# MM11

TECHNICAL  
INFORMATION  
COMPANY CONFIDENTIAL

EP-MM11-TI-A  
COPYRIGHT © 1978  
FICHE 1 OF 1

Title QUALADYNE 1540 SENSE AMPS				Tech Tip MM11 Number 01	
All	Processor Applicability	Author DON ZERESKI	Rev A	Cross Reference	
		Approval CHUCK DEWEY	Date 6/27/72

digital	CORE MEMORY STACK (Y DRIVER)	D-BS-MM1E-03	REV B
	ENGINEERING CHANGE ORDER

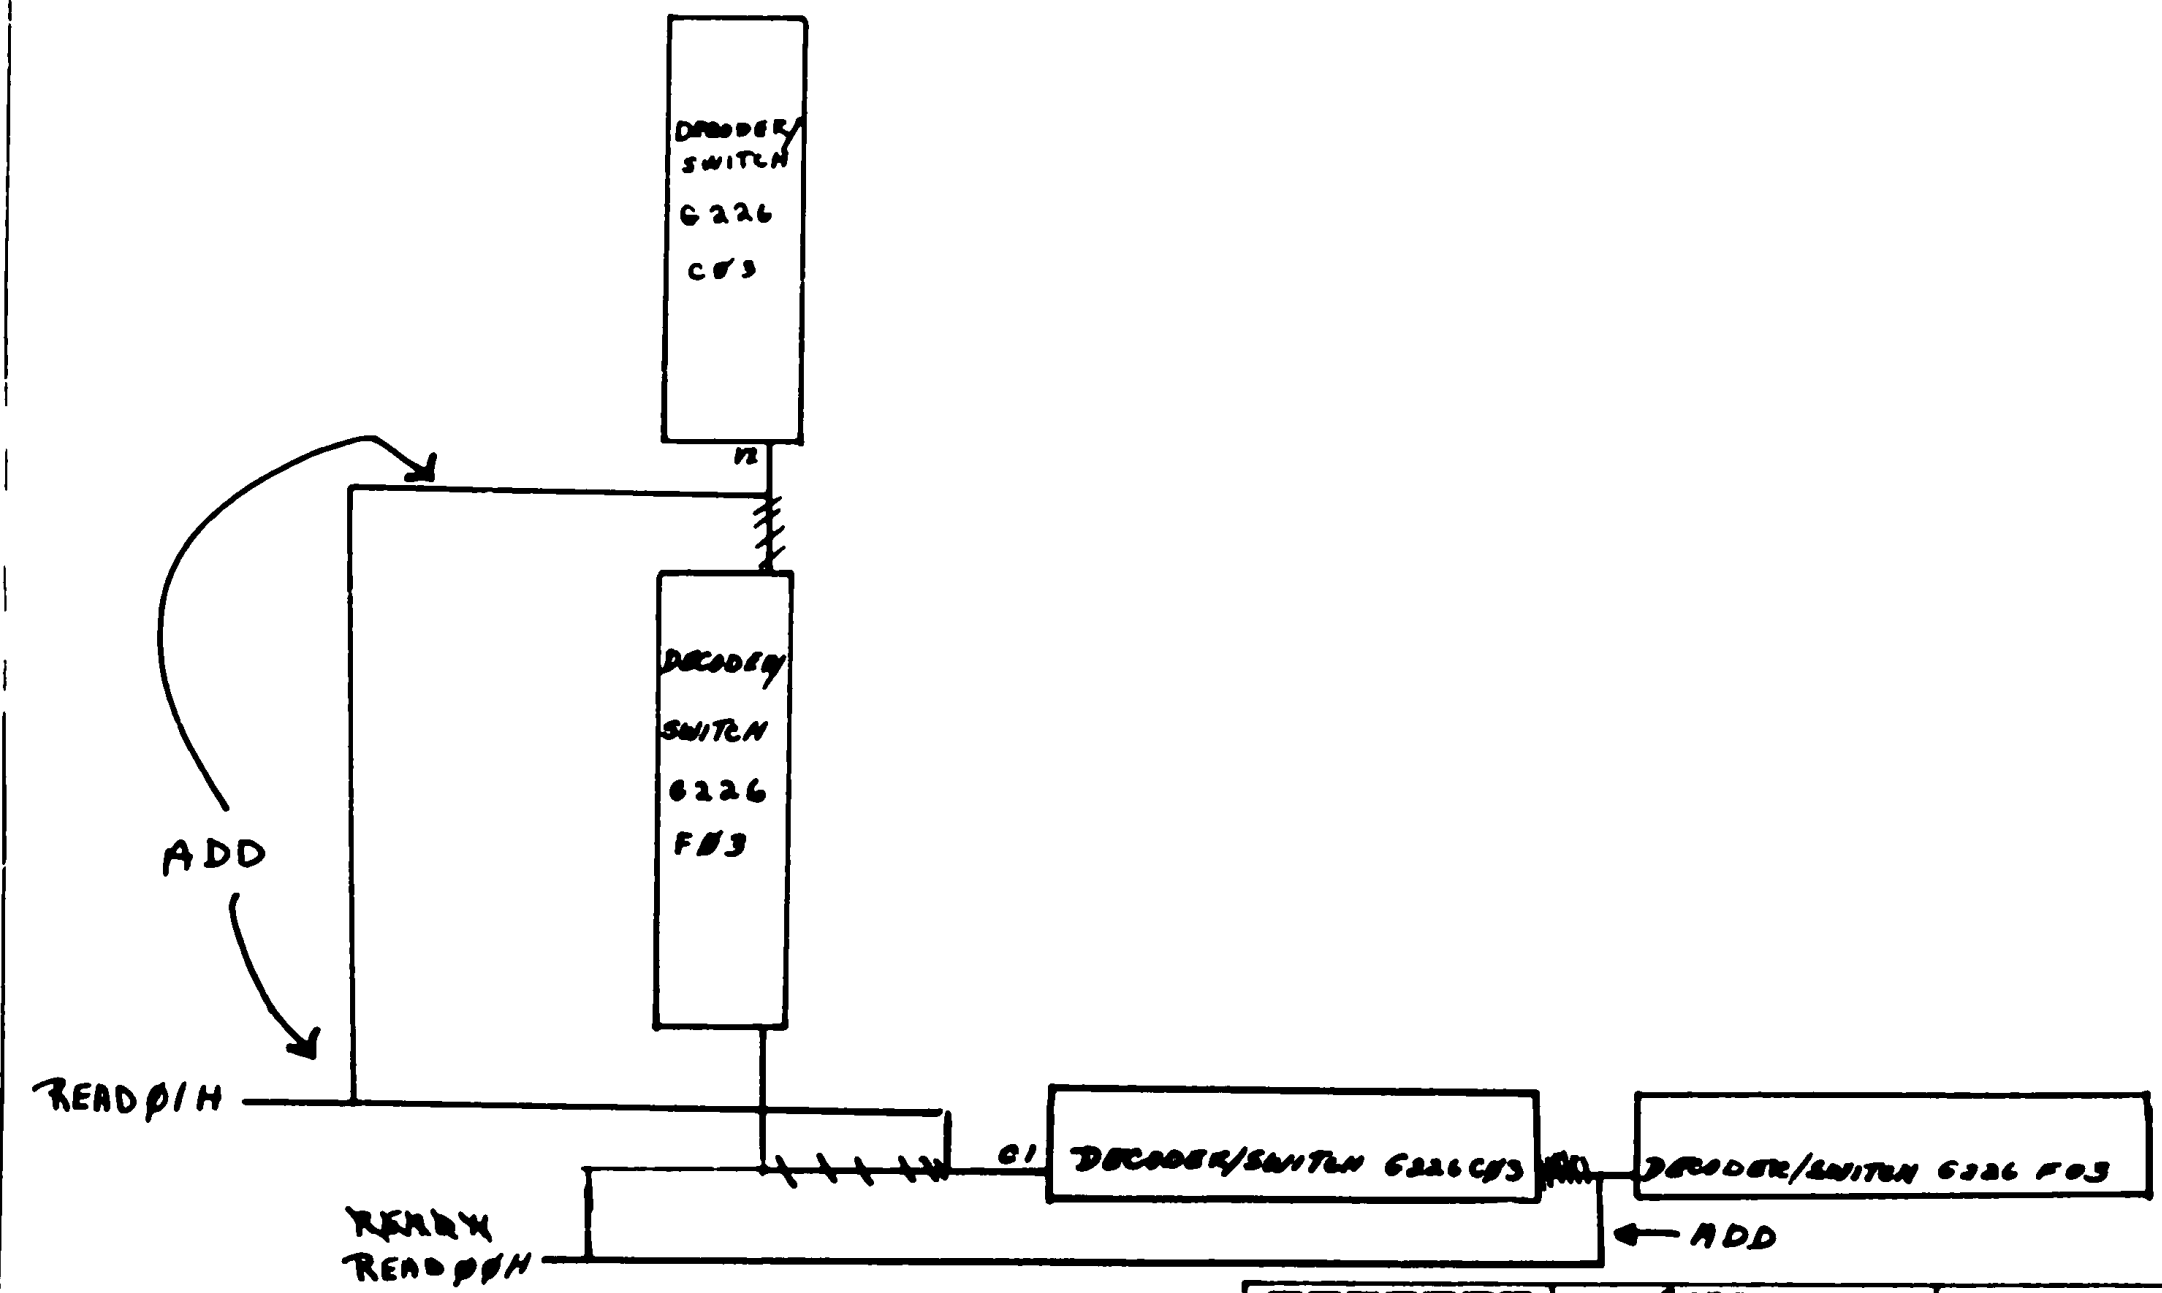
ENGINEERING CHANGE ORDER	CORP. MEMORY STACK DRIVE	NO. D-BS-MM11E-03	REV B
	URN Cathy	REV. 01	GRAPHIC DESCRIPTION

ECO NO MM11F-0003

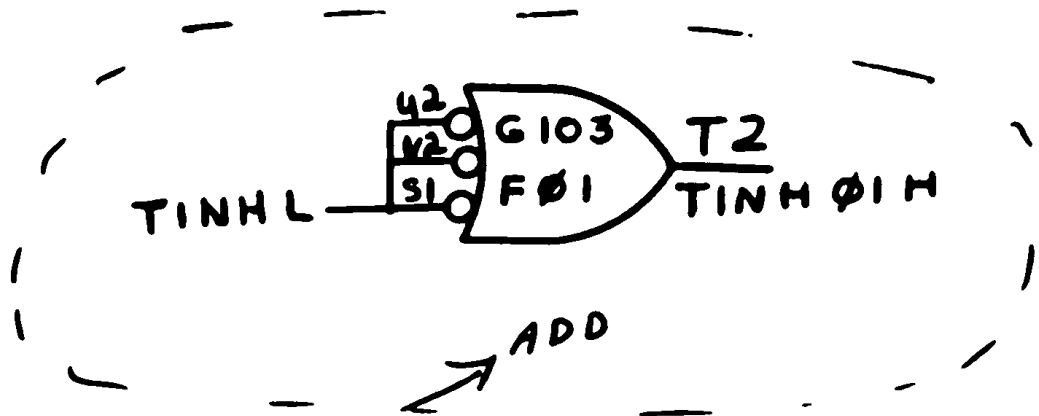
1. Strobe signals and TINH have too much noise on them.
2. Read H signal has too many loads on it.
3. Solves memory problems caused by DMA transfers that memory diagnostics don't show up, also, solves slot sensitive G103, G102 problems.

SIGNAL NAME	FROM PIN	TO PIN	COMPONENTS	ADD	DEL
TINH H	C01C1	D02E1			X
TINH H	D03E1	E03E1			X
TINH H	E01E1	F01E1			X
STROBE 0 H	C01R1	D02S1			X
STROBE 01 H	C01R1	E01S1			X
TSS H	F01V2	F01P1			X
TINH L	C01K1	F01S1		X	
TINH L	F01S1	F01V2		X	
TINH L	F01V2	F01V2		X	
TINH 0 H	C01C1	D02E1	WHT	TWP	X
GND	C01C2	D02C2	RED		X
TINH 01 H	F01T2	F01E1	WHT	TWP	X
GND	F01T1	F01C2	RED		X
TINH 01 H	F01T2	E02E1	WHT	TWP	X
GND	F01T1	E02C2	RED		X
STROBE 0 H	C01R1	D02S1	WHT	TWP	X
GND	C01T1	D02T1	RED		X
STROBE 01 H	C01R1	E01S1	WHT	TWP	X
GND	C01C2	E01T1	RED		X

ITEM NO	DOCUMENT/PART NO.	OLD REV	NEW REV	DISP CODE	DESCRIPTION OF CHANGE
1	K-WL-MM11-F-07	-	A	06	Update wire list.
2	A-PL-MM11-F-0	A	B	06	Update Rev. per this ECO.
3	A-ML-MM11-F	C	D	06	Update.
4	D-AD-7007263-0-0	-	A	06	Wire Ass'y MM11/F. See final release print.
5	D-BS-MM11-F-03	-	A	06	Core memory stack (2 sheets) See final release print.
6	A-PL-7007263-0-0	-	A	06	Update revision level.
